## DEPARTMENT OF ENERGY

### 10 CFR Part 430

### Energy Conservation Program for Consumer Products: Test Procedures for Refrigerators, Refrigerator-Freezers, and Freezers

**ACTION:** Final rule.

**Figure 1**

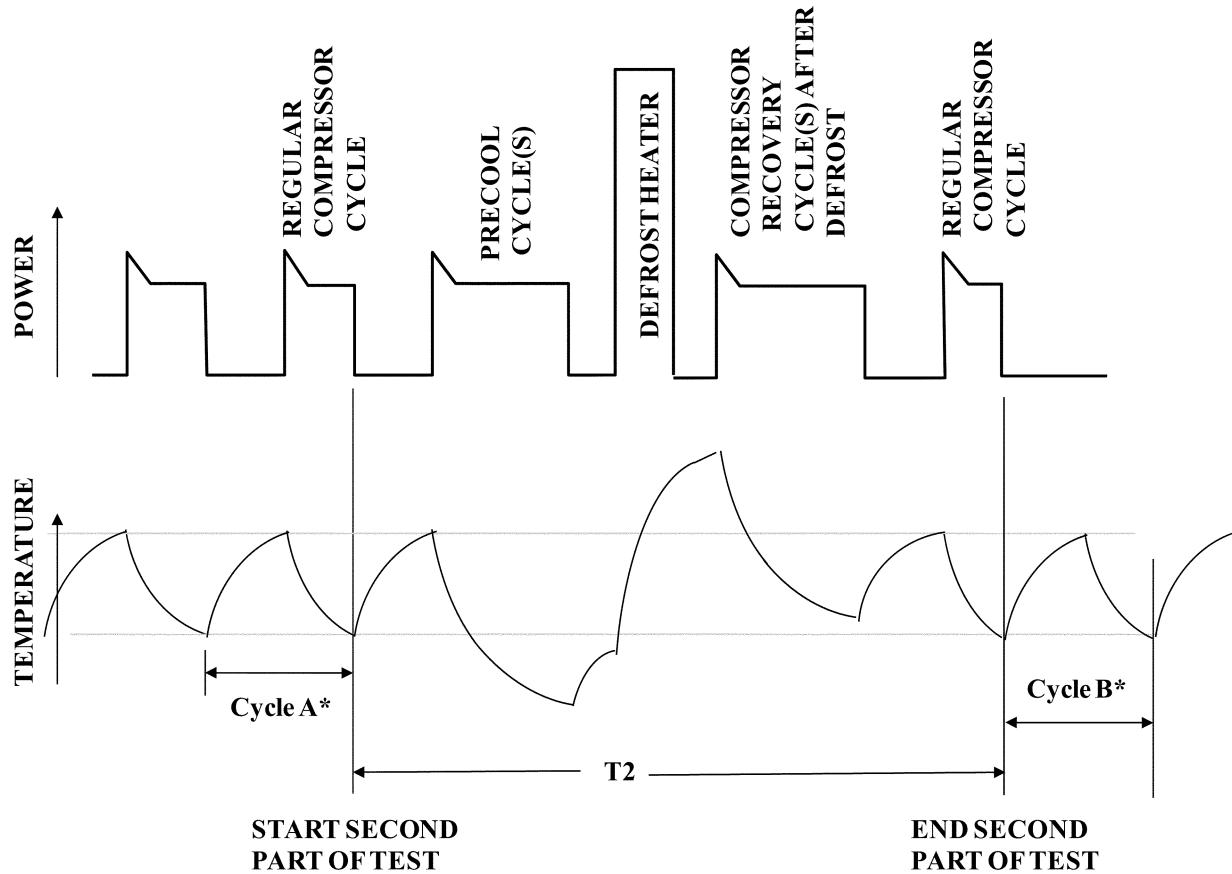
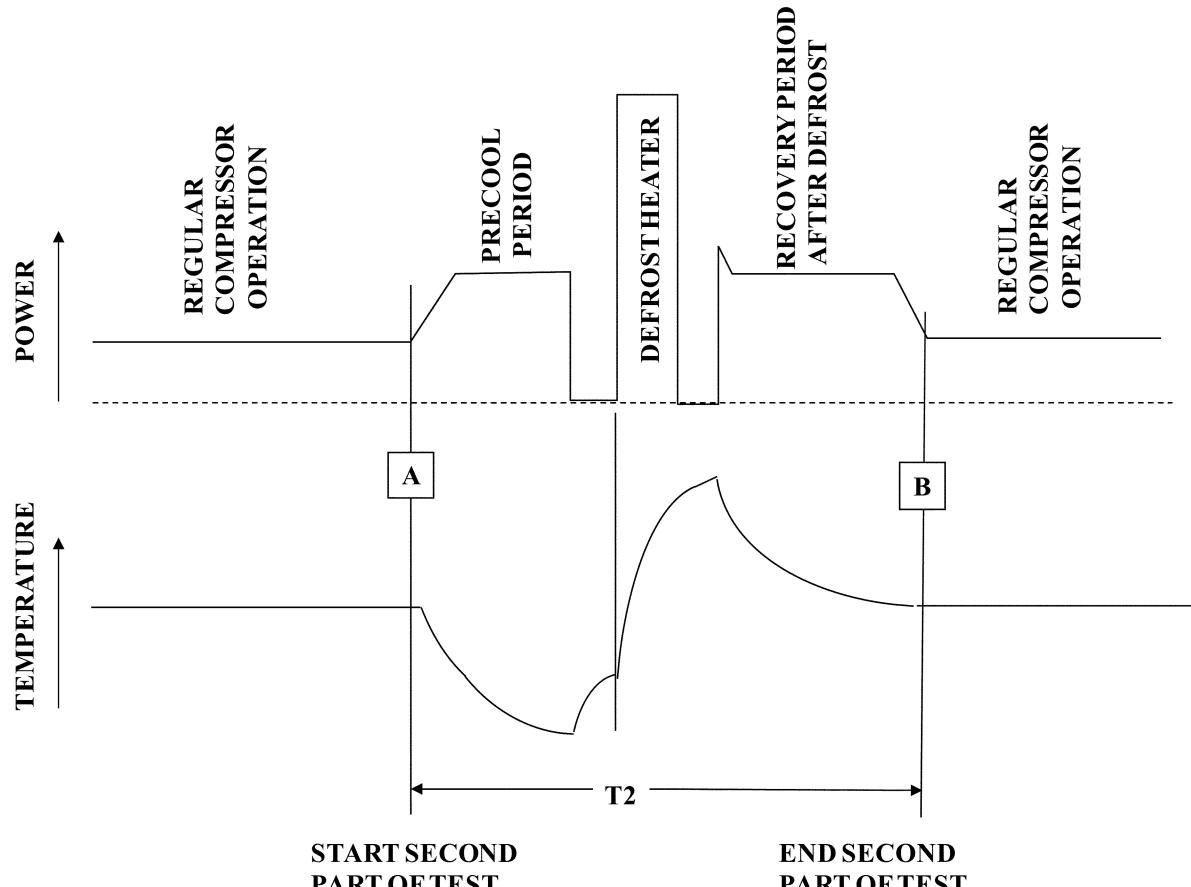
4.2.1.1 **Cycling Compressor System.** For a system with a cycling compressor, the second part of the test starts at the termination of the last regular compressor "on" cycle. The average temperatures of the fresh food and freezer compartments measured from the termination of the previous compressor "on" cycle to the termination of the last regular compressor "on" cycle must both be within 0.5 °F (0.3 °C) of their average temperatures measured for the first part of the test. If any compressor cycles occur prior to the defrost heater being energized that cause the average temperature in either compartment to deviate from its average temperature for the first part of the test by more than 0.5 °F (0.3 °C), these compressor cycles are not considered regular compressor cycles and must be included in the second part of the test. As an example, a "precooling" cycle, which is an extended compressor cycle that lowers the temperature(s) of one or both compartments prior to energizing the defrost heater, must be included in the second part of the test. The test period for the second part of the test ends at the termination of the first regular compressor "on" cycle after both compartment temperatures have fully recovered to their stable conditions. The average temperatures of the compartments

measured from this termination of the first regular compressor "on" cycle until the

termination of the next regular compressor "on" cycle must both be within 0.5 °F (0.3

°C) of their average temperatures measured for the first part of the test. See Figure 1.

**\*Average compartment temperature(s) during cycles A & B must be within 0.5 °F of the average temperature(s) for the first part of the test.**

**Figure 1****Long-time Automatic Defrost Diagram for Cycling Compressors**

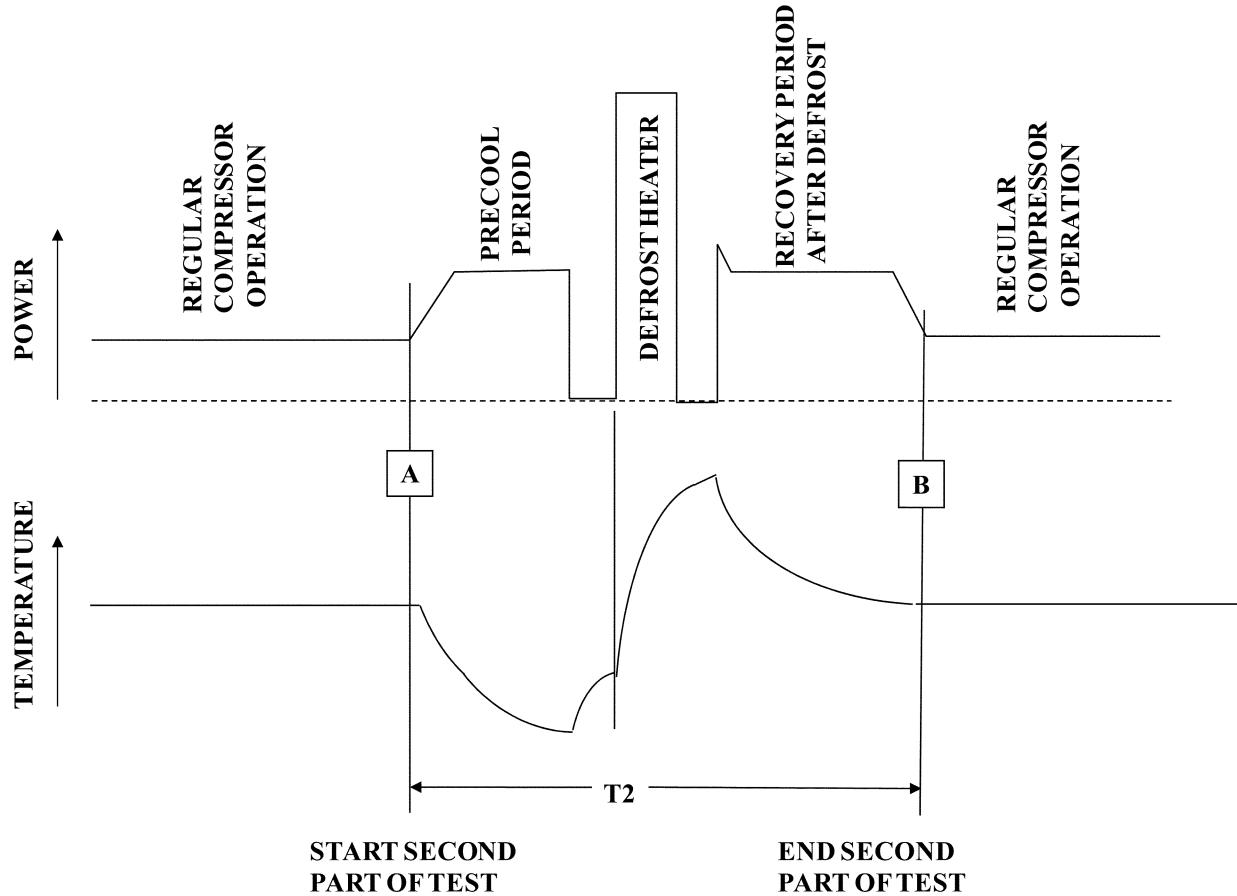
4.2.1.1 Cycling Compressor System. For a system with a cycling compressor, the second

part of the test starts at the termination of the last regular compressor “on” cycle. The average temperature of the compartment measured from the termination of the previous compressor “on” cycle to the termination of the last regular compressor “on” cycle must be within 0.5 °F (0.3 °C) of the average temperature of the compartment measured for the first part of the test. If any compressor cycles occur prior to the defrost heater being energized that cause the average temperature in the compartment to deviate from the average temperature for the first part of the test by more than 0.5 °F (0.3 °C), these compressor cycles are not considered regular compressor cycles and must be included in the second part of the test. As an example, a “precooling” cycle, which is an extended compressor cycle that lowers the compartment temperature prior to energizing the defrost heater, must be included in the second part of the test. The test period for the second part of the test ends at the termination of the first regular compressor “on” cycle after the compartment temperatures have fully recovered to their stable conditions. The average temperature of the compartment measured from this termination of the first regular compressor “on” cycle until the termination of the next regular compressor “on” cycle must be within 0.5 °F (0.3 °C) of the average temperature of the compartment measured for the first part of the test. See Figure 1.

**\*Average compartment temperature during cycles A & B must be within 0.5 °F of the average temperature for the first part of the test.**
